CITY OF PORTLAND, MAINE
PLANNING BOARD

AGENDA
PORTLAND PLANNING BOARD MEETING

210 Valley Street Development
Level III Site Plan, Subdivision & Conditional Use Review
Avesta Valley Street, LP, Applicant
PL-001075-2020 CBL: 064 F007

Submitted to: Portland Planning Board Public Hearing Date: August 18, 2020	Prepared by: Andrew Tufts, Planner Date: August 14, 2020

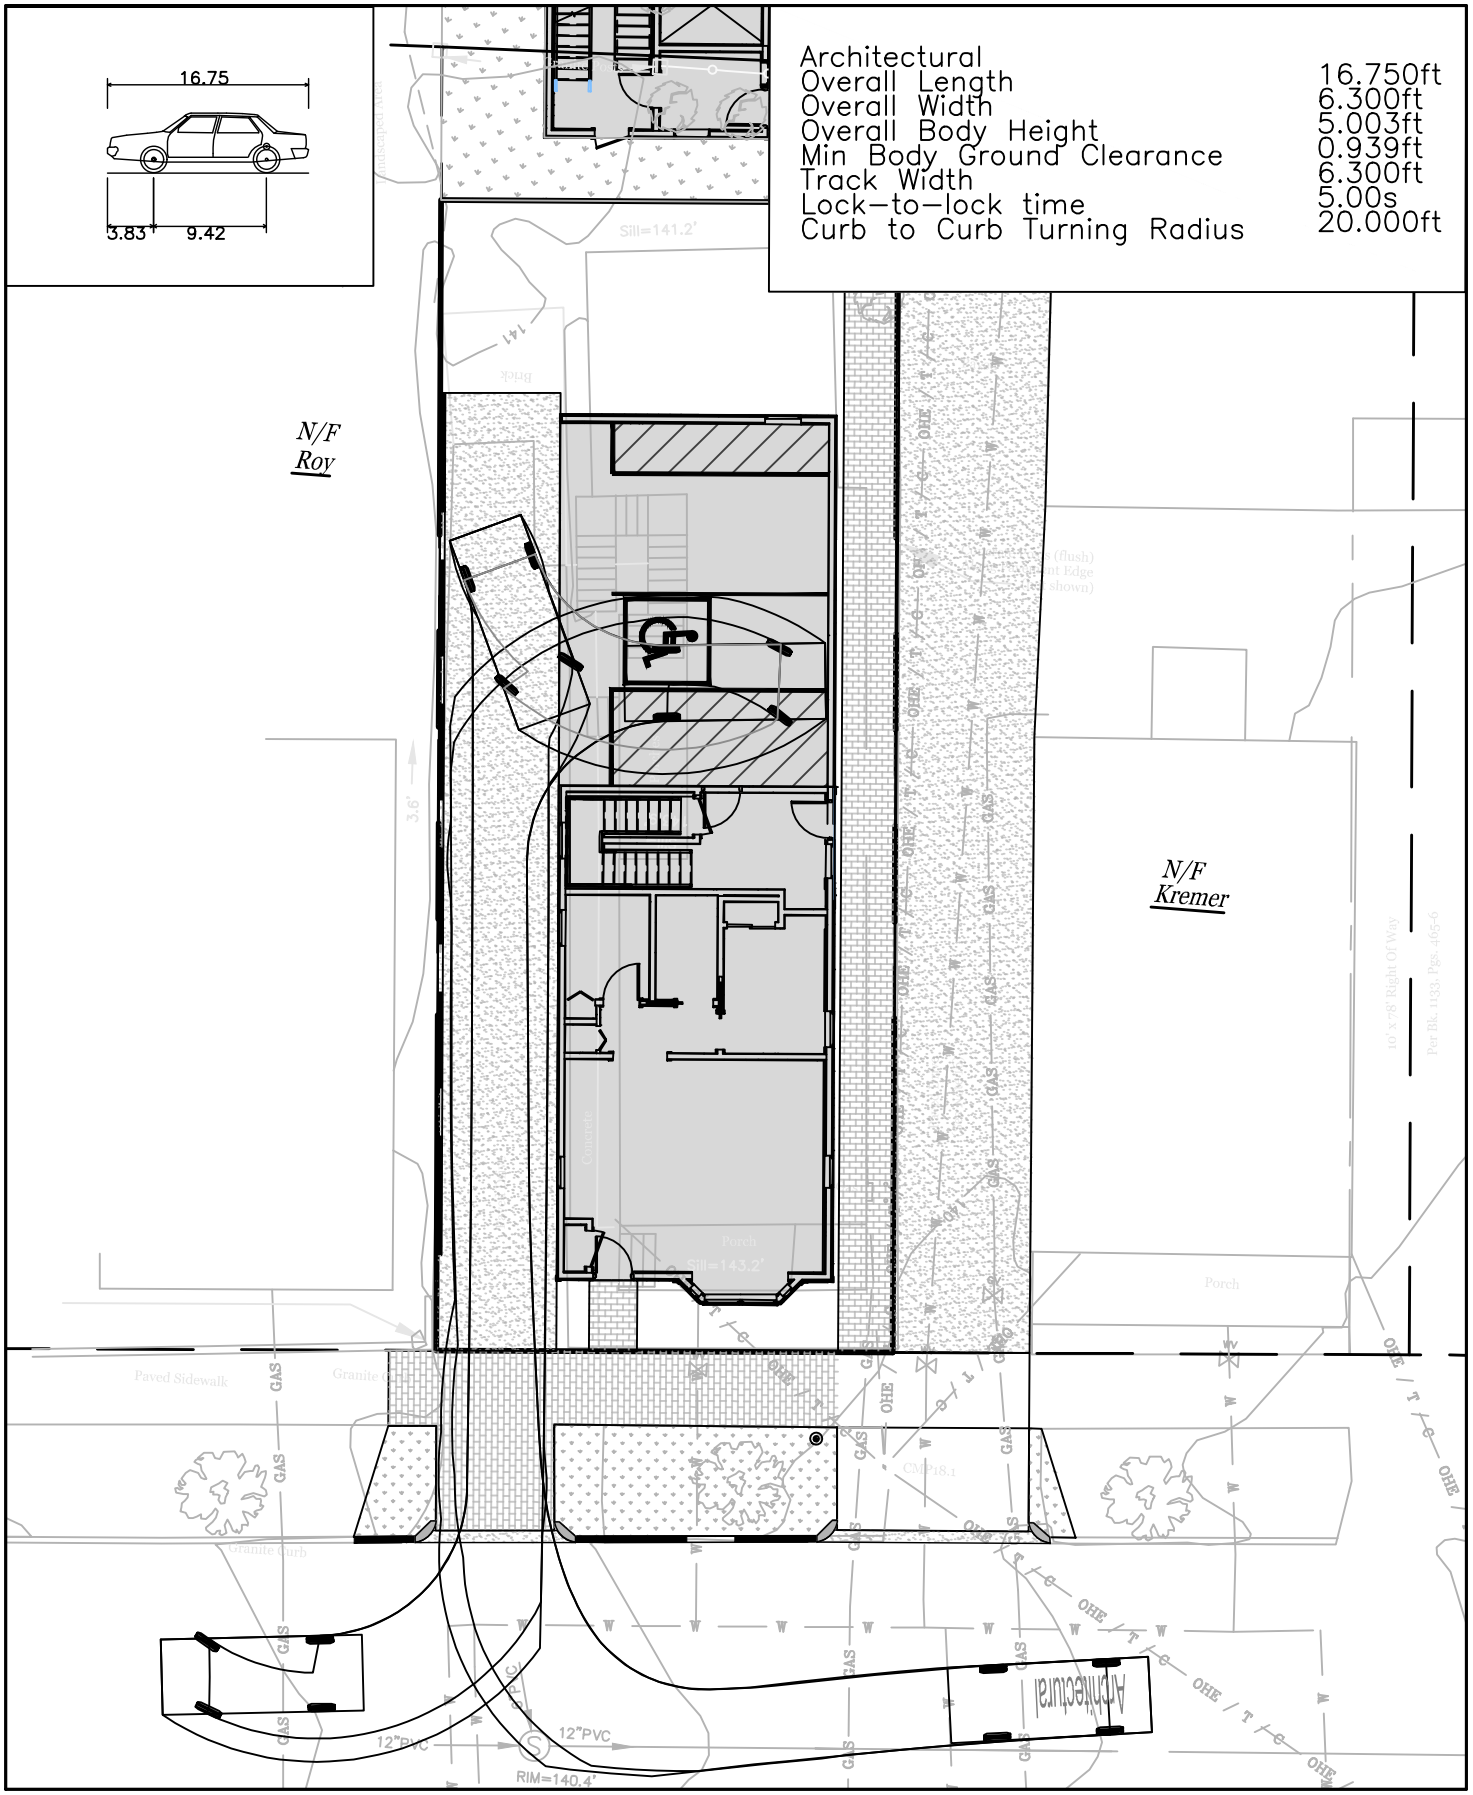
Comment – *The electric meter for 126 North is proposed for the front of the house. This should be relocated to the side if at all possible.*

Response – The meters have been relocated to the side of the building.

Drawing A-1.1.

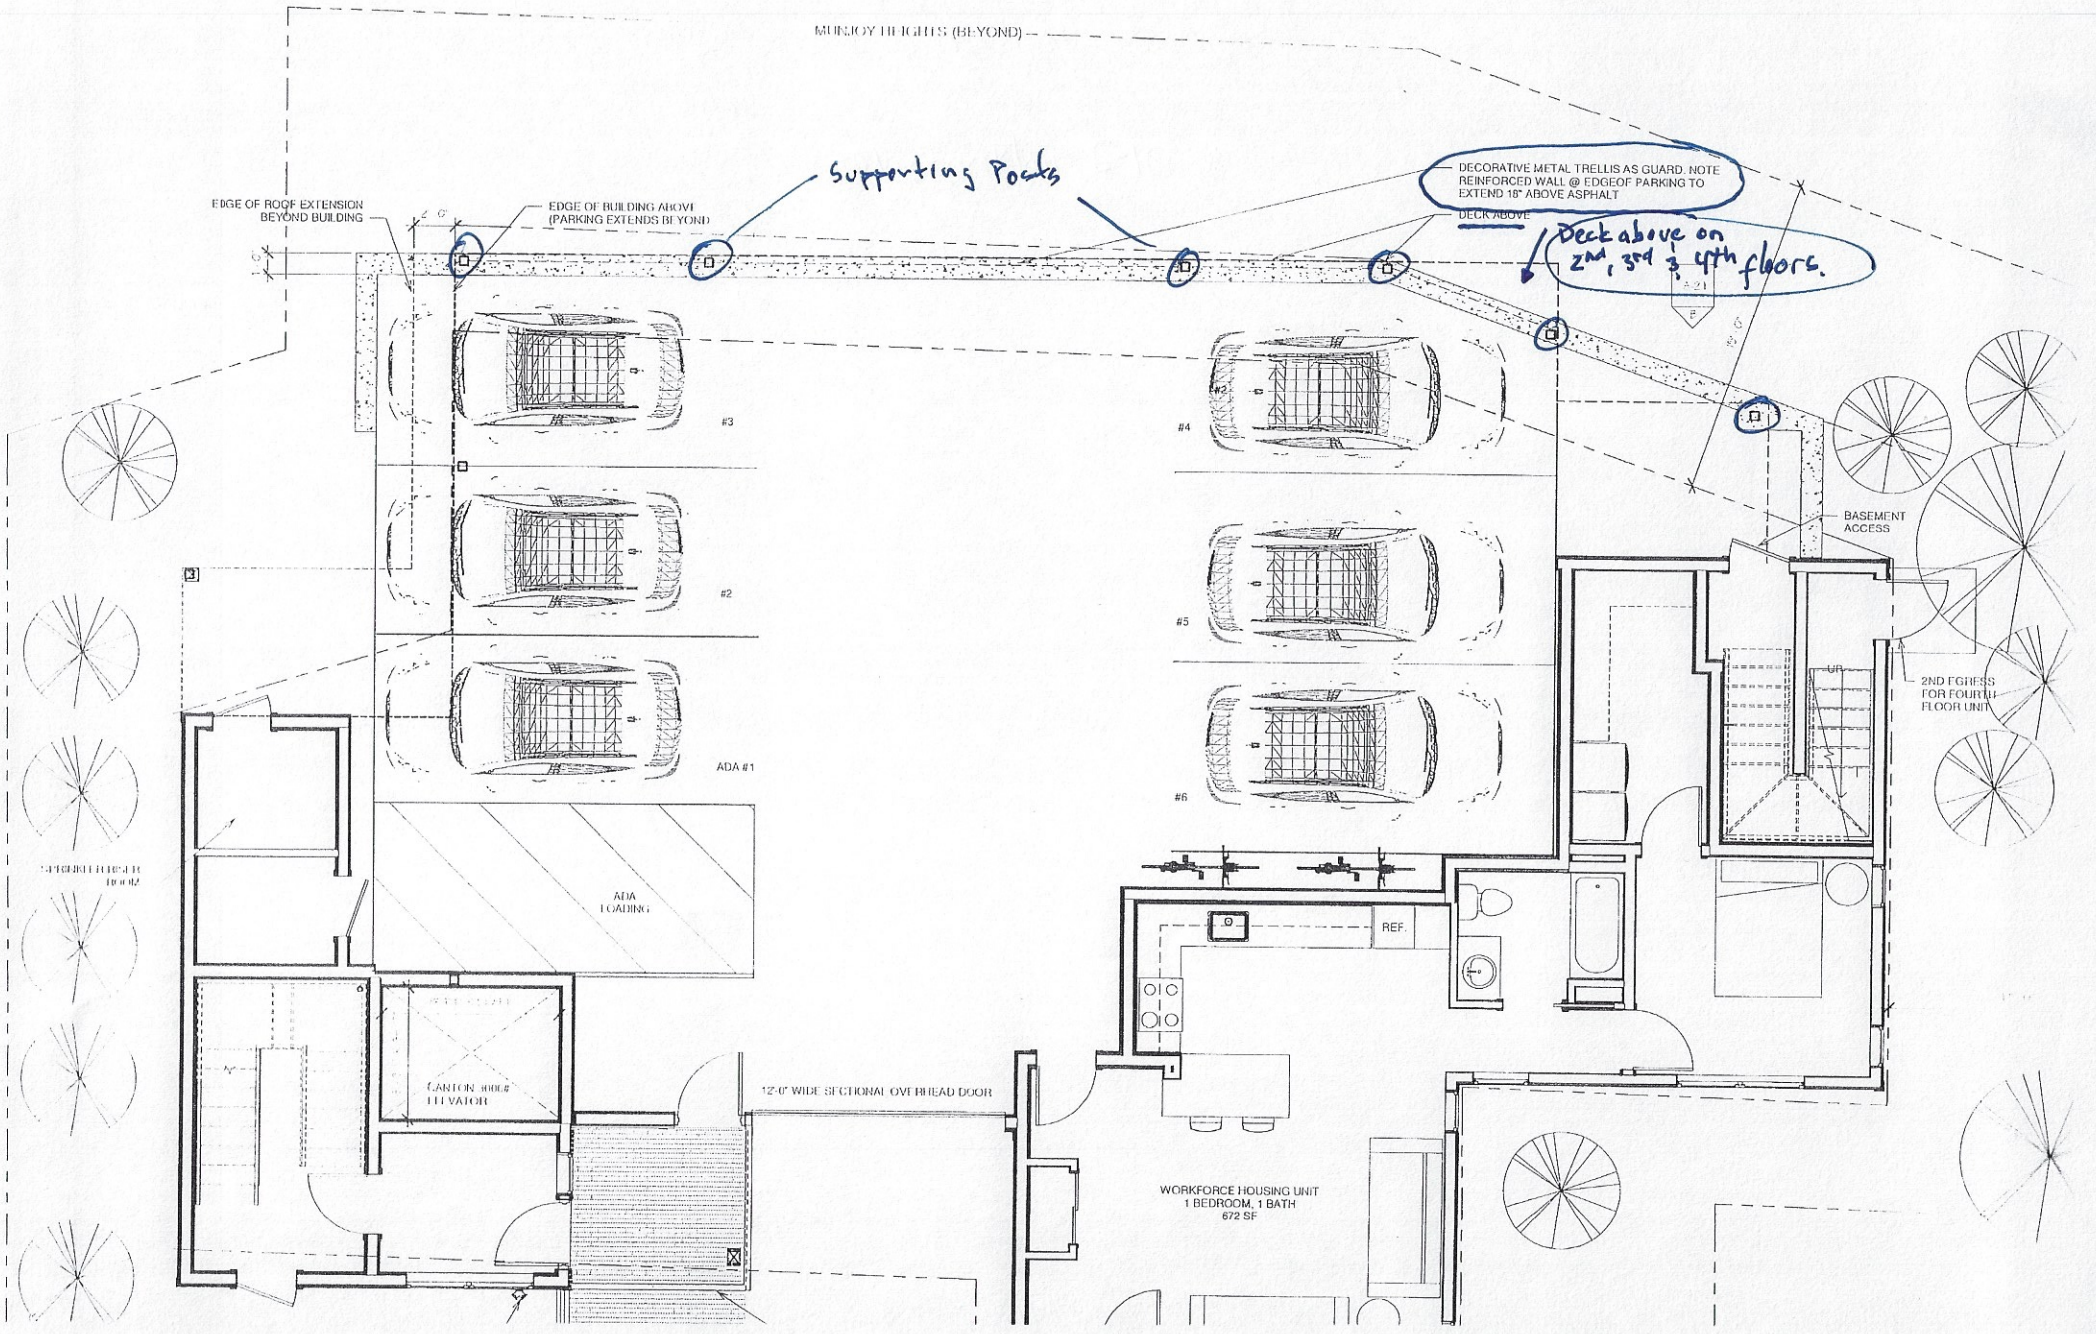
Beginning at about 8' off the ground, the second, third, and fourth floor decks protrude into the maintenance easement such that it is narrowed down to 7.61' wide rather than the 10' wide as granted. **See the attached Drawing A-1.1 and Master Plan C-10 with area of protruding decks circled.** Given the size and the significance of the retaining wall separating 128R North Street and the Munjoy Heights development, Upright Properties, LLC does not have the right unilaterally to narrow the maintenance easement and thereby constrain the maneuverability of heavy equipment as contemplated by the easement. As such, the applicant is proposing a development that exceeds the developer's rights to the property.

Hovering Posts

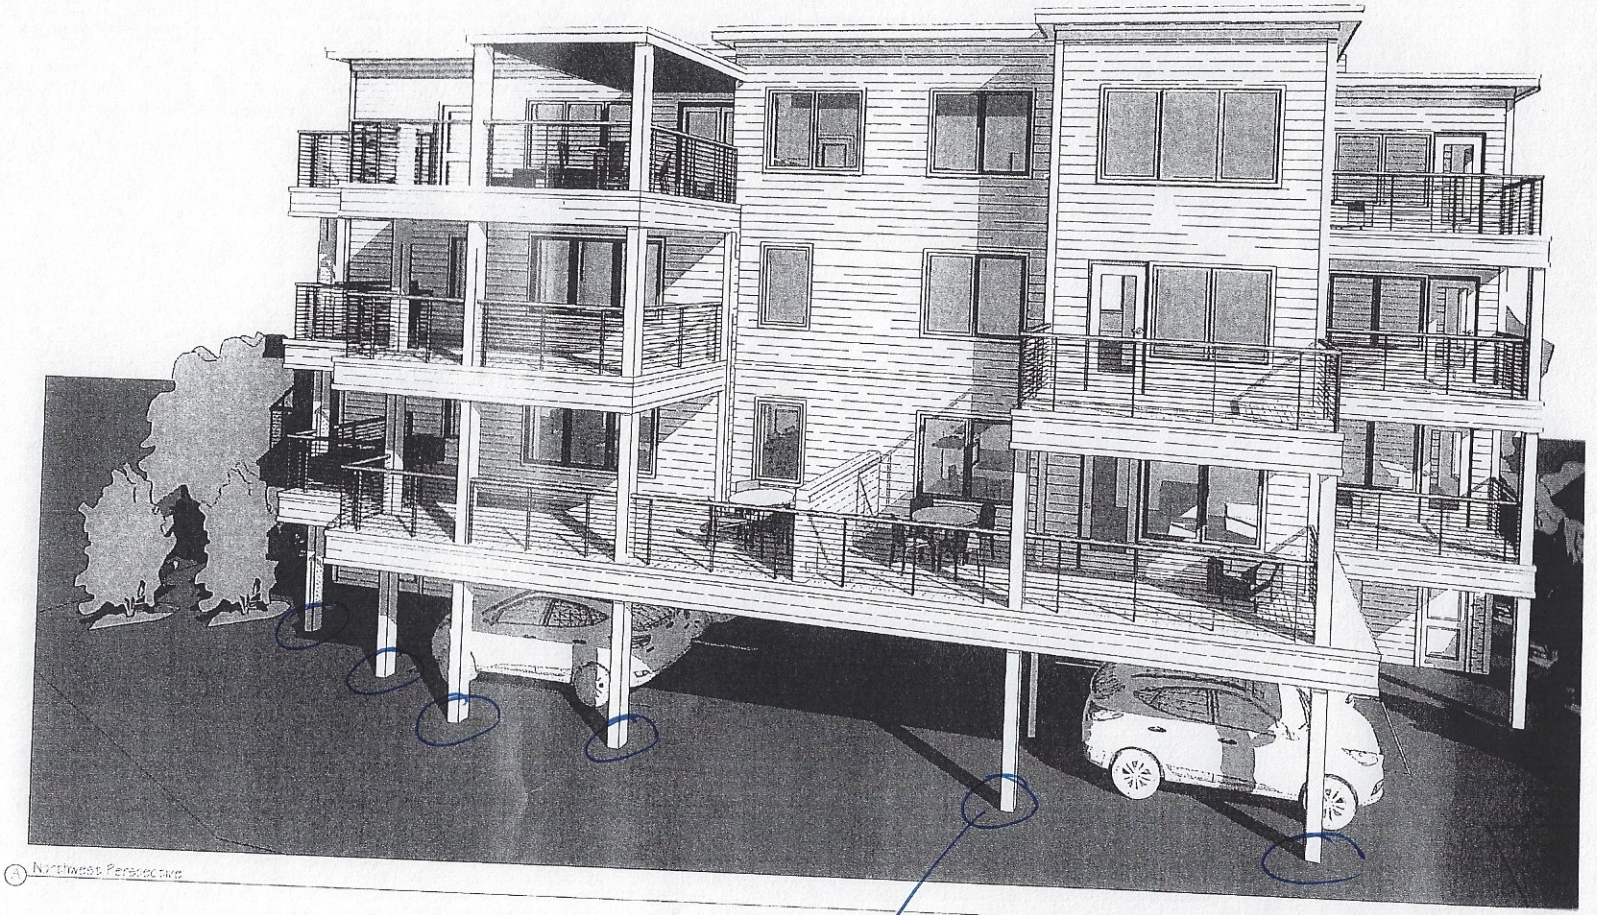
The proposed Master Site Plan (**Drawing C-10 attached**) shows a proposed concrete wall located about 2' from the property line in the south rear corner of the site and 10' from the property line for most of the rest of it. The proposed First Floor Plan (**Drawing A-1.1 attached**) notes that the concrete wall is exposed a foot and a half above the asphalt parking area and shows six posts set in the concrete wall to support the structure above. The posts are also depicted in the attached rendering but are depicted as hovering off the ground instead of showing the concrete foundation wall supporting them (**Rendering A-5.2 labeled "Hovering Posts" attached).**
